## **ADDENDUM NO. 2**

### REPLACEMENT OF THAMES STREET WALL AT ELECTRIC BOAT GROTON, CT

MMI #2536-13  
December 4, 2019

SCALE: AS NOTED  
 DATE: NOVEMBER 22, 2019  
 PROJECT NO.: 2536-13  
 DRAWING NO.: MPT-01

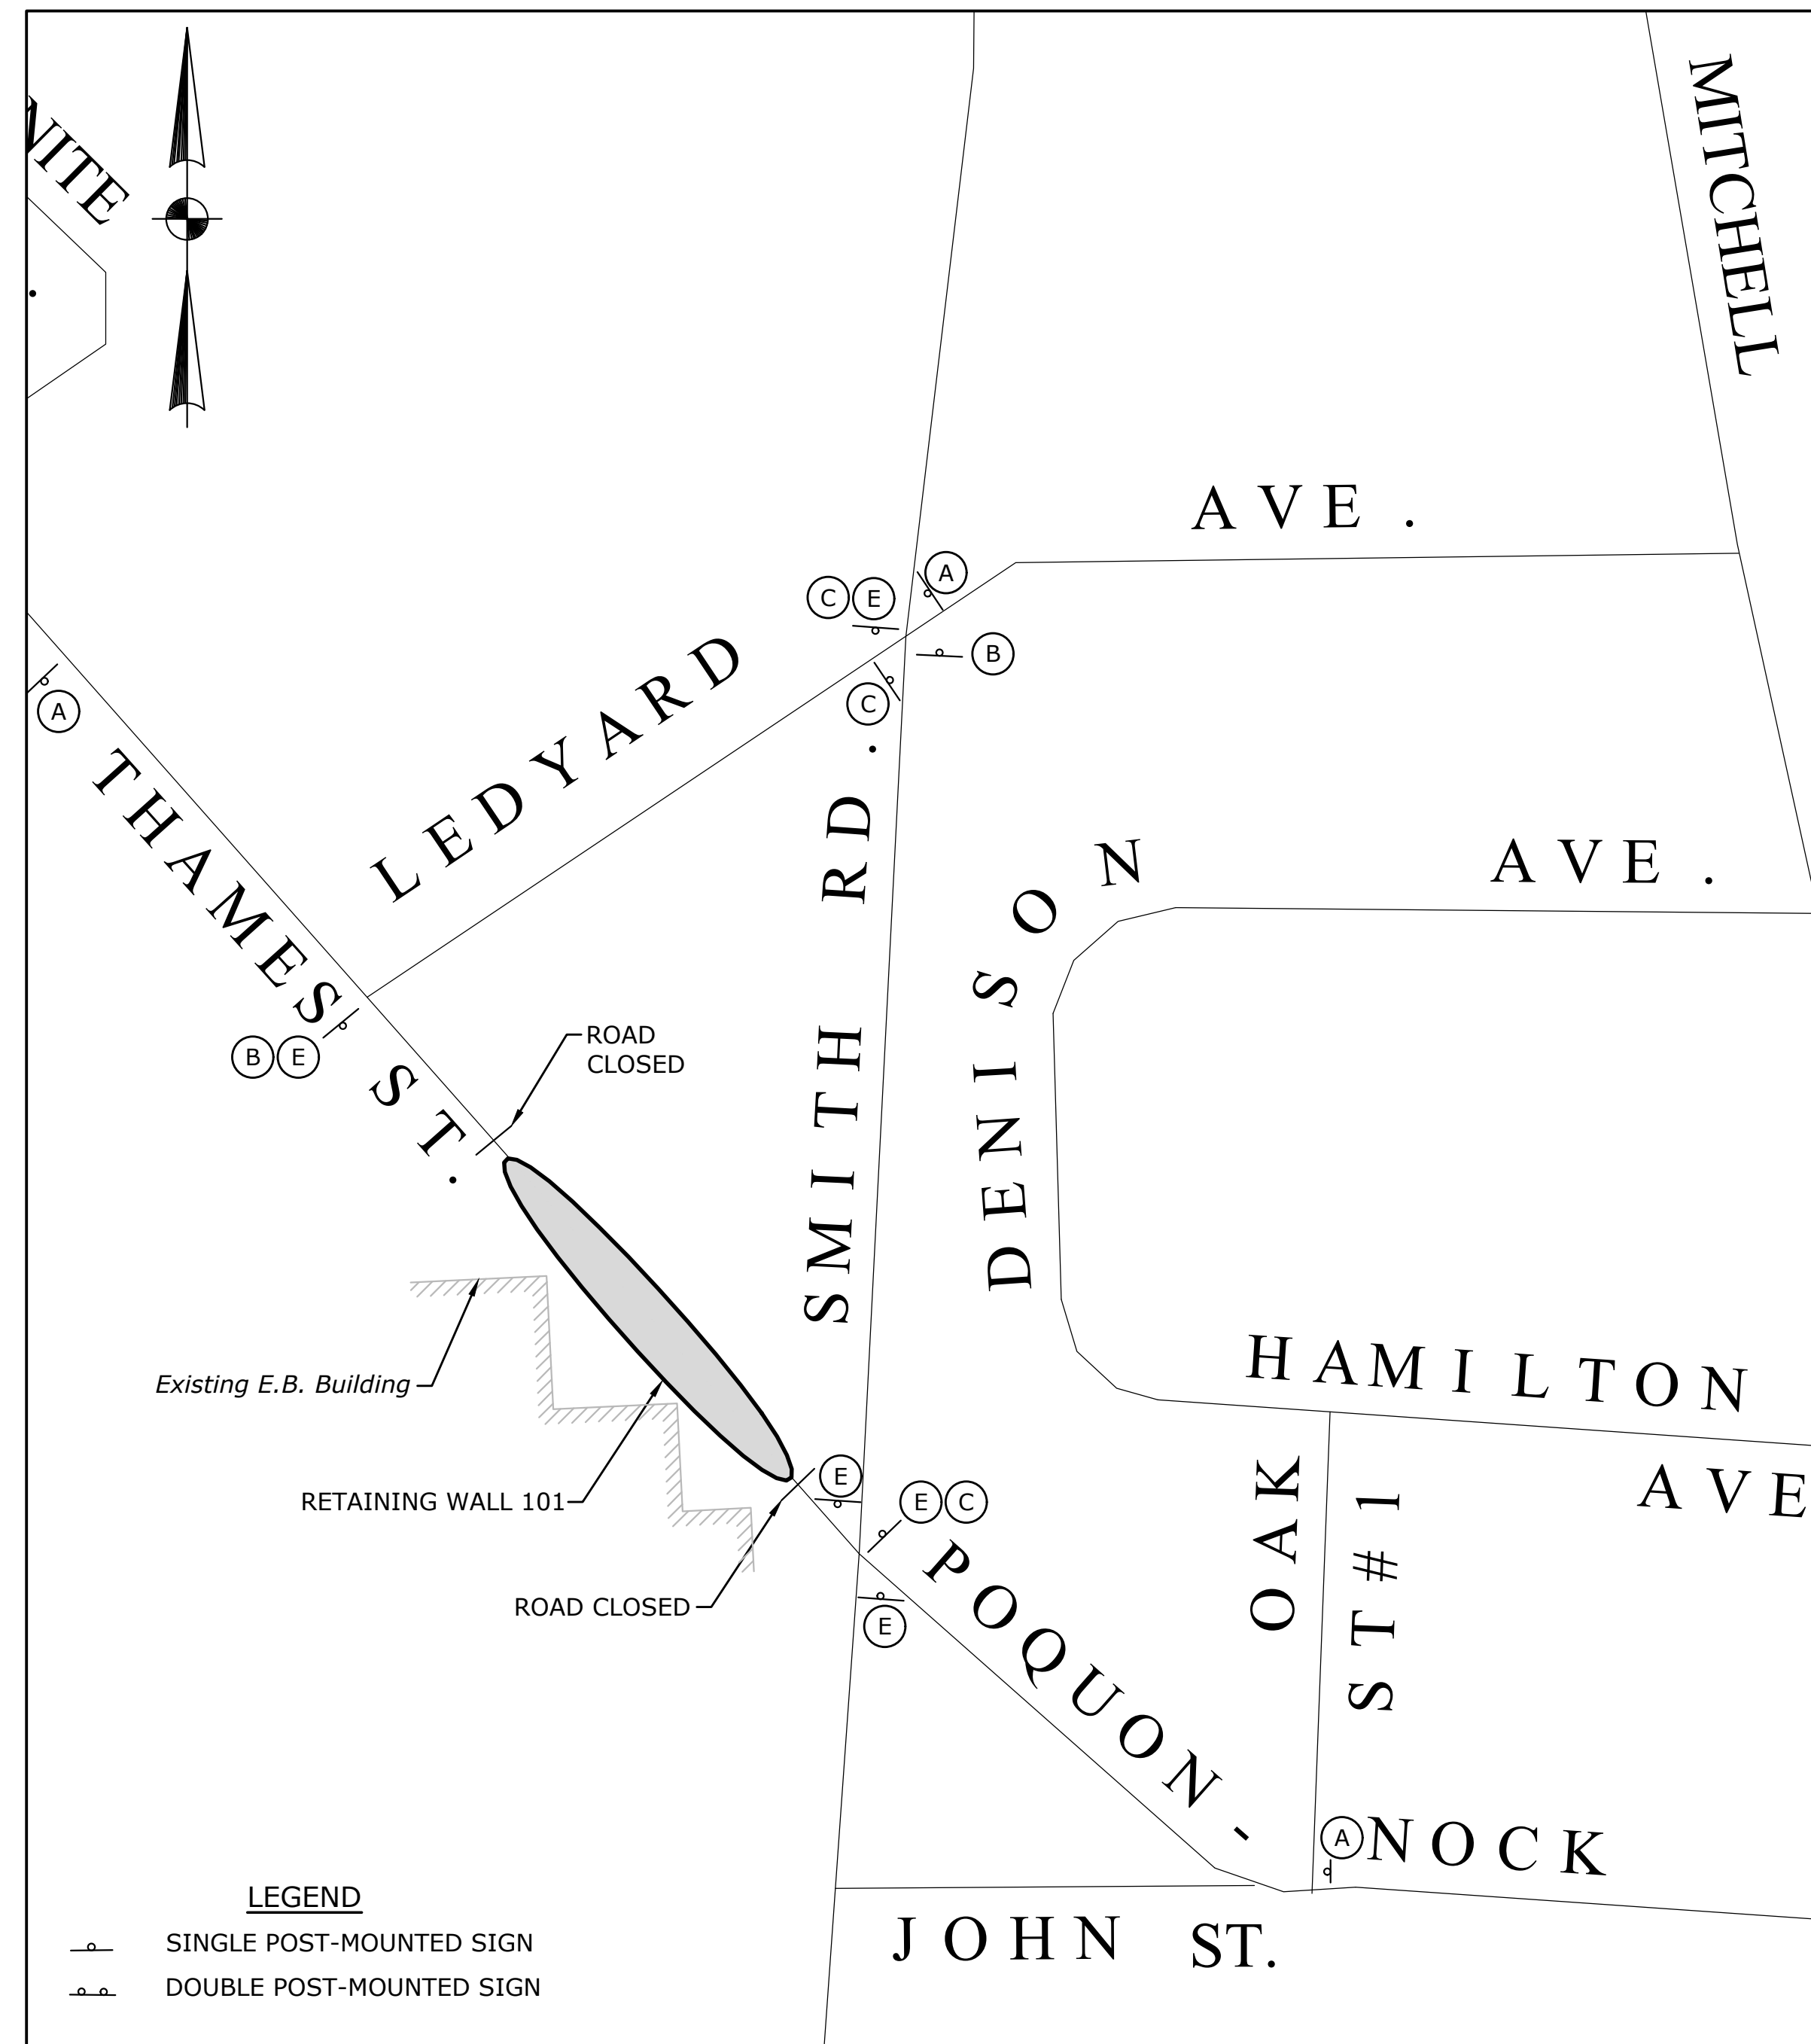
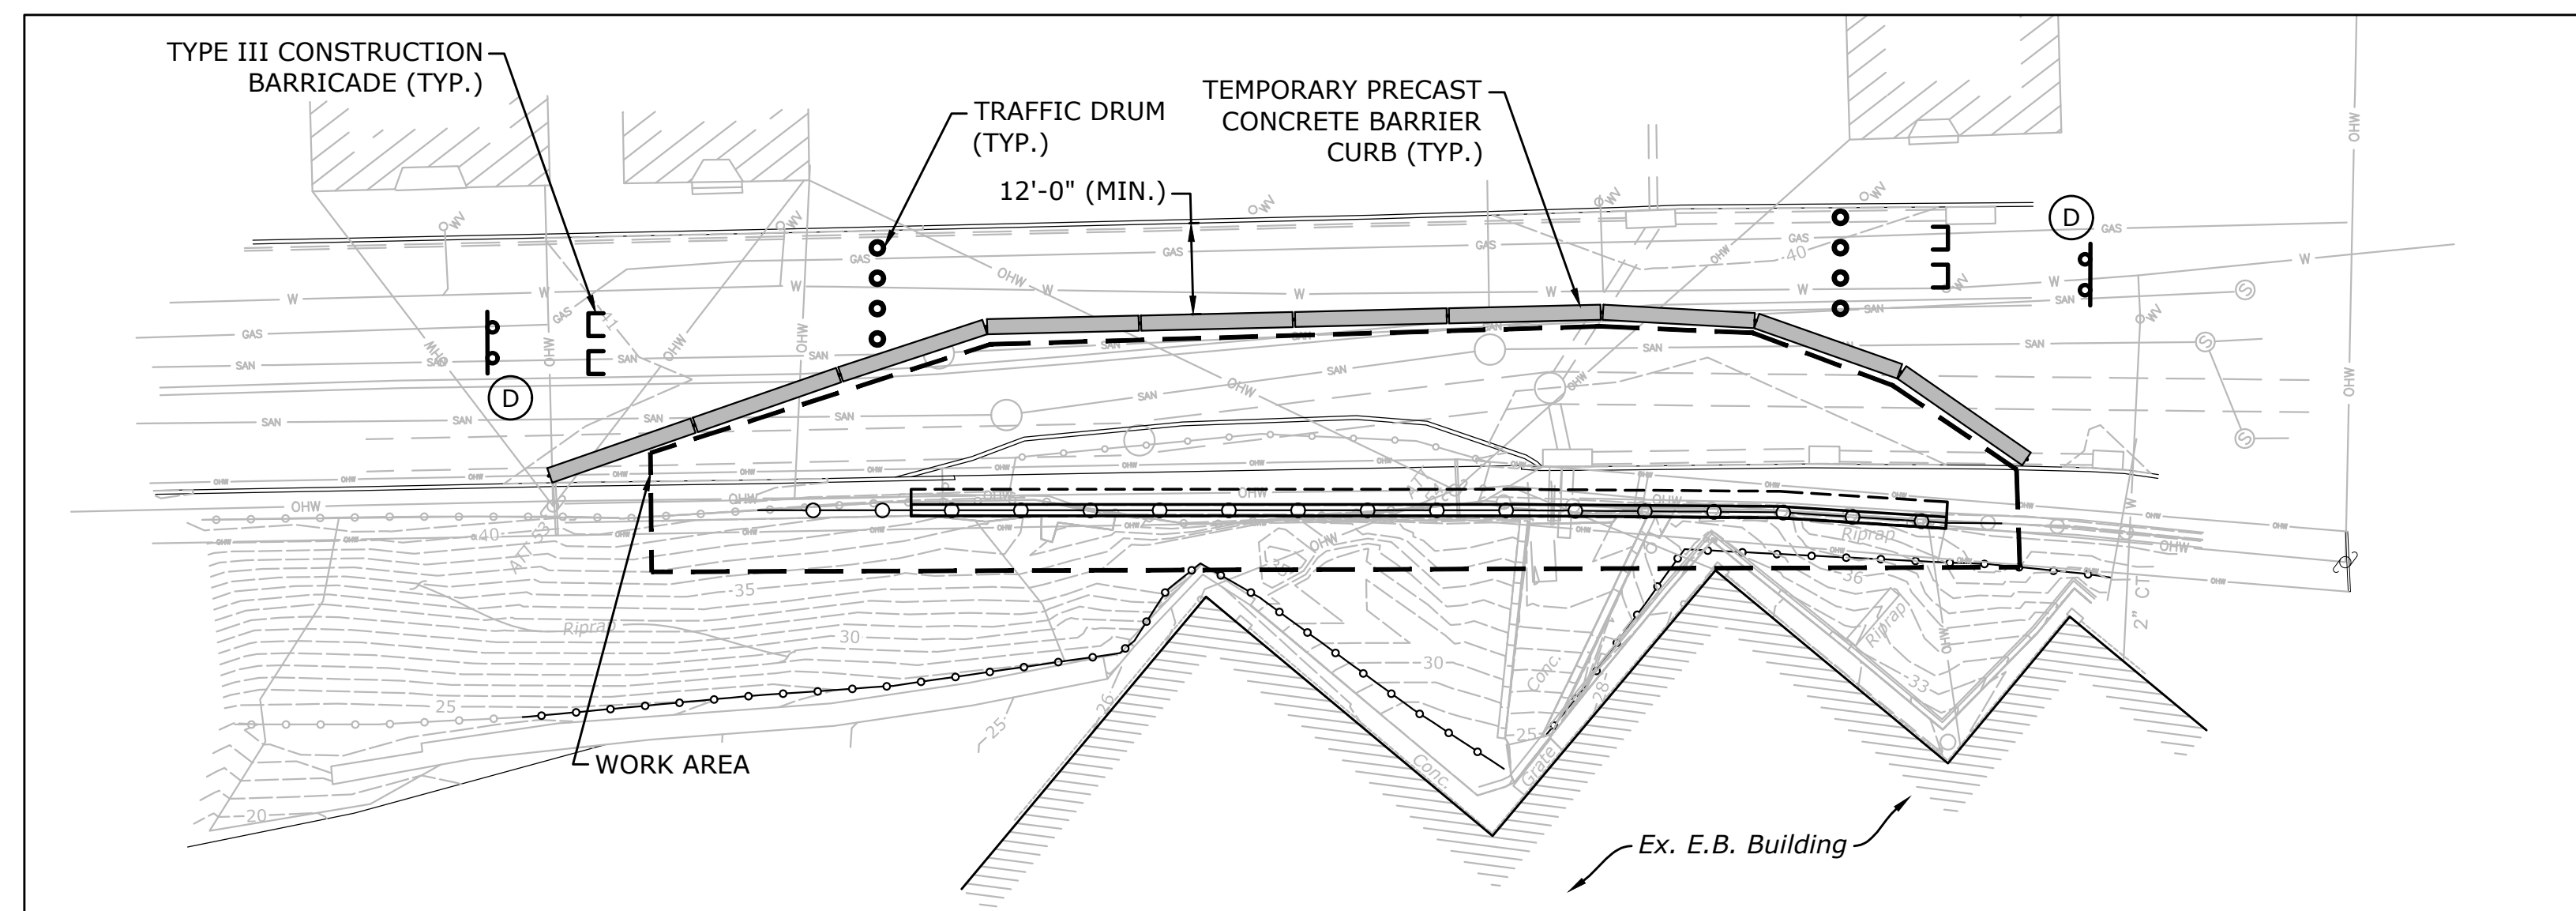
- As discussed in the Pre-Bid Meeting the detour plan has been modified to add additional signs to direct larger vehicles to detour at Mitchell Street from the State Route 95 exit as it will be difficult for larger vehicles to turn onto Ledyard to Smith Street.

| KP                      | NP    | KP      |
|-------------------------|-------|---------|
| DRAWING NO.: STR-01     |       |         |

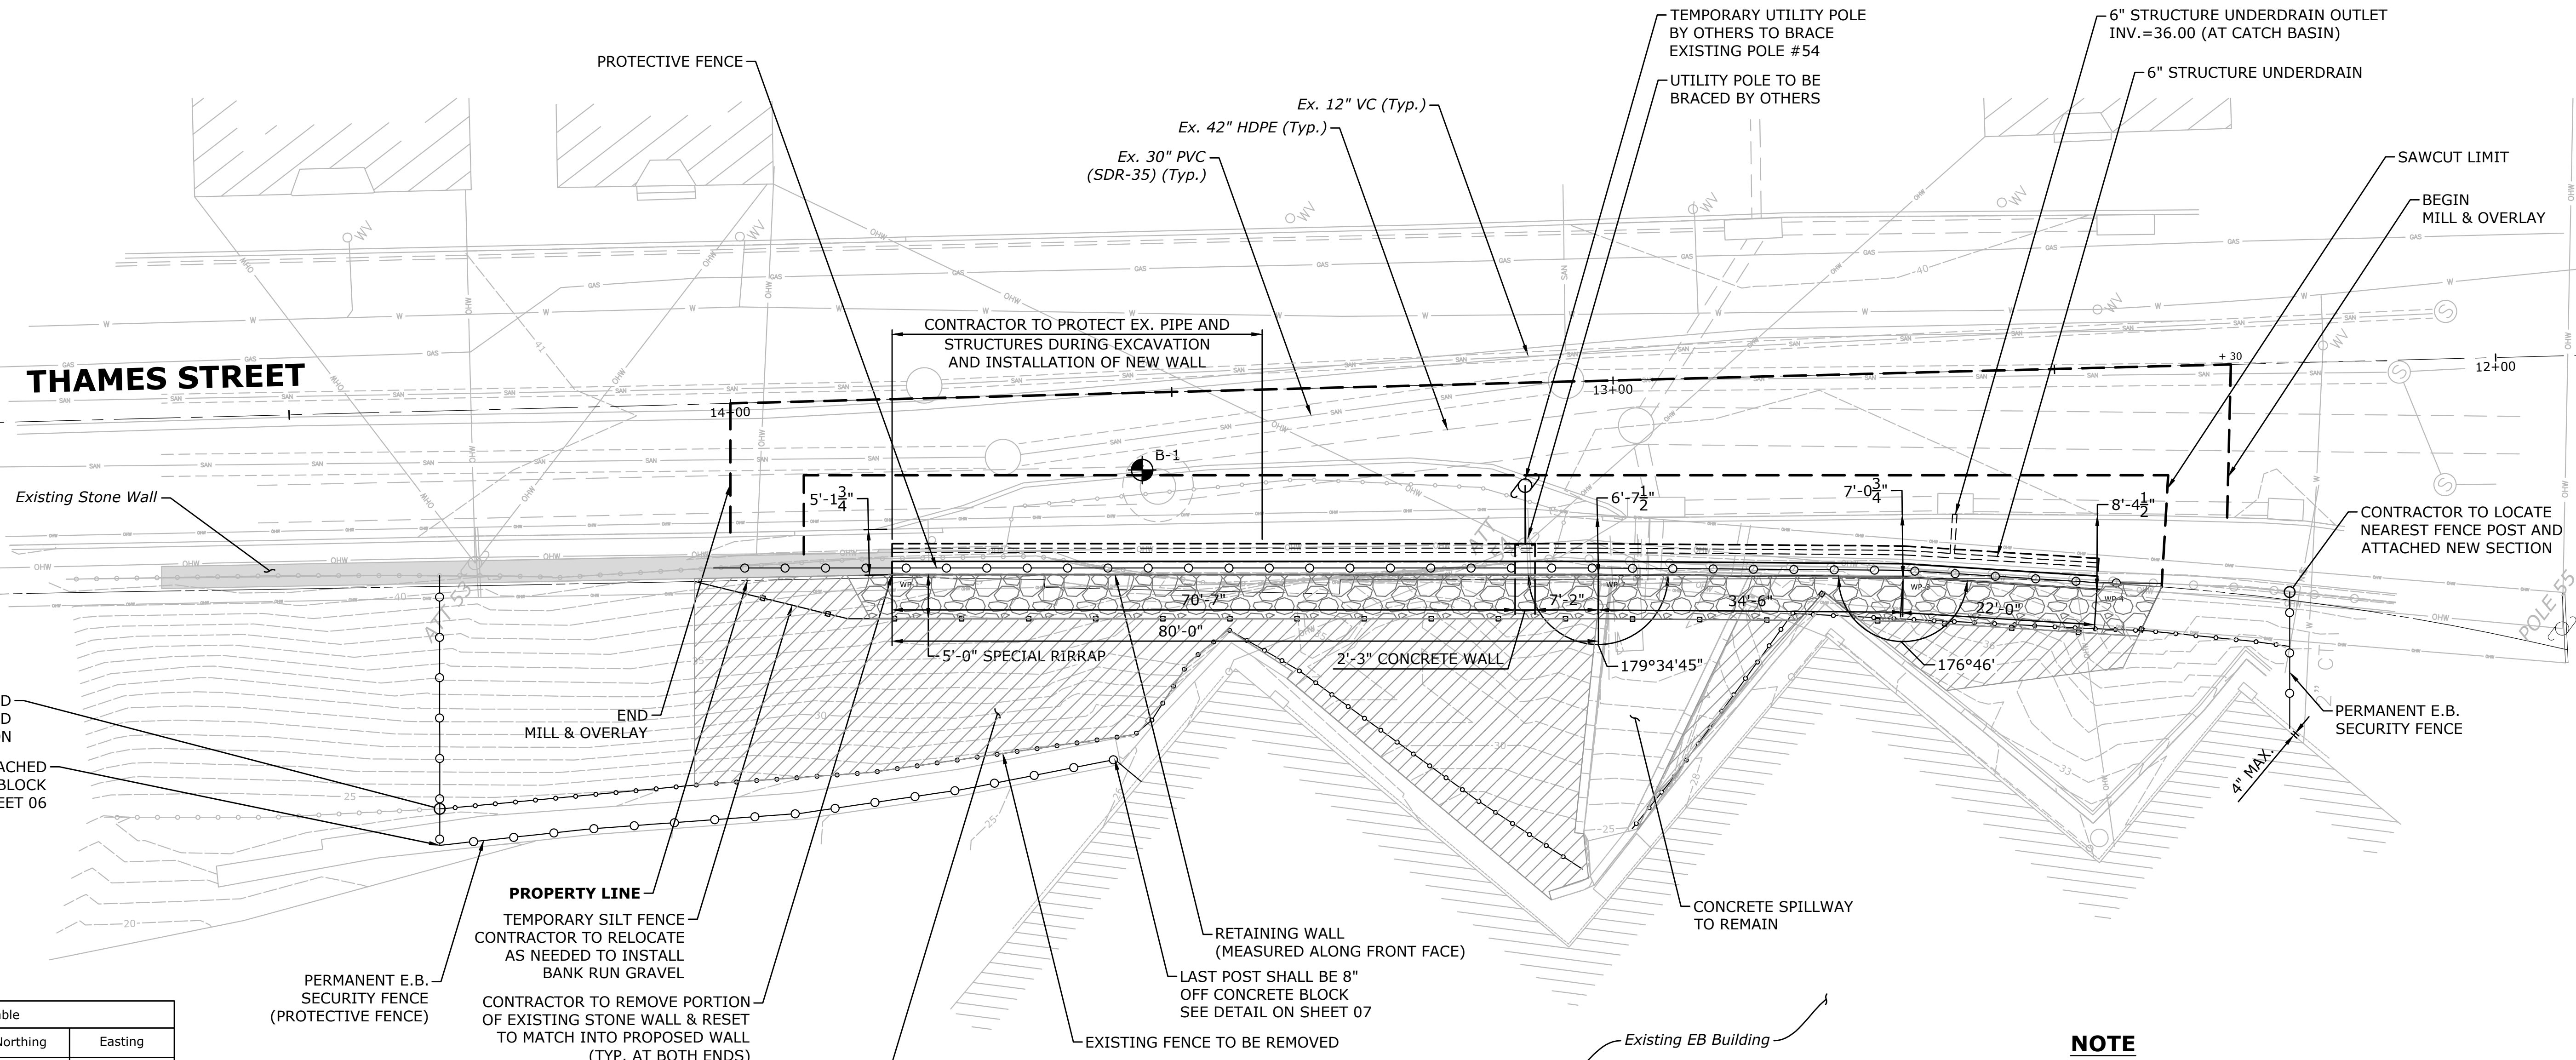
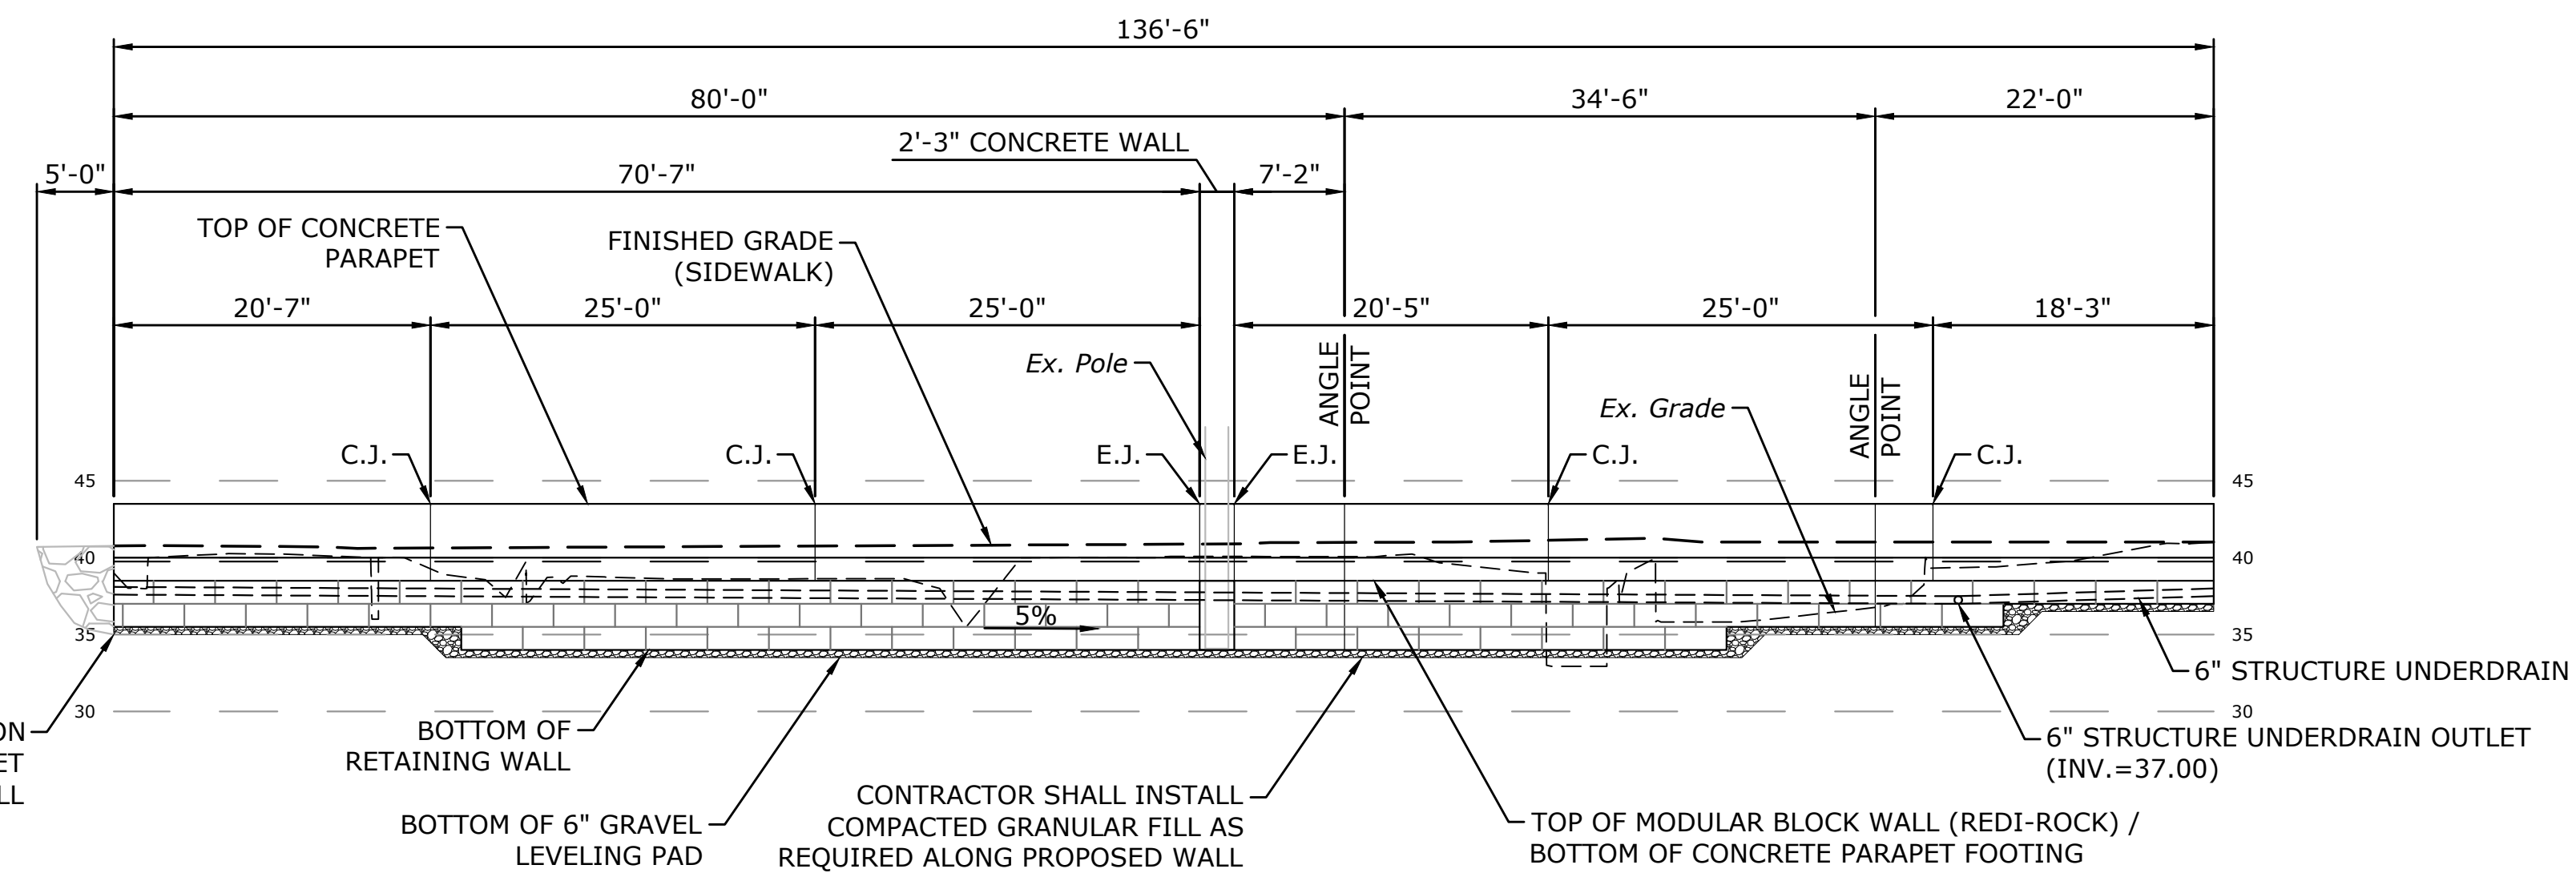
**Q1: What are the new limits of the Edge of Roadway, Bituminous Concrete Curb, and Bituminous Concrete Walk? These are not clearly shown on the plans?**

**Q2: How is the 6" Perforated Pipe within the Drainage Aggregate behind the new wall to be paid for?**

**R1:** The sawcut limit line shown on sheet STR-01 shall be the extents for the bituminous concrete curb and walk. The existing edge of roadway (gutter line) within the sawcut limits shall be maintained, where the gutter line has collapsed station +/- 13+00 to +/- 13+85 strike a line from catch basin at station 13+00 to station 13+85.

**R2:** See revised sheet STR-01, the 6" Structure Underdrain and 6" Structure Underdrain Outlet shall be included in the item "Embankment Wall (Site No. 1)". The structure underdrain is shown plan and elevation view.
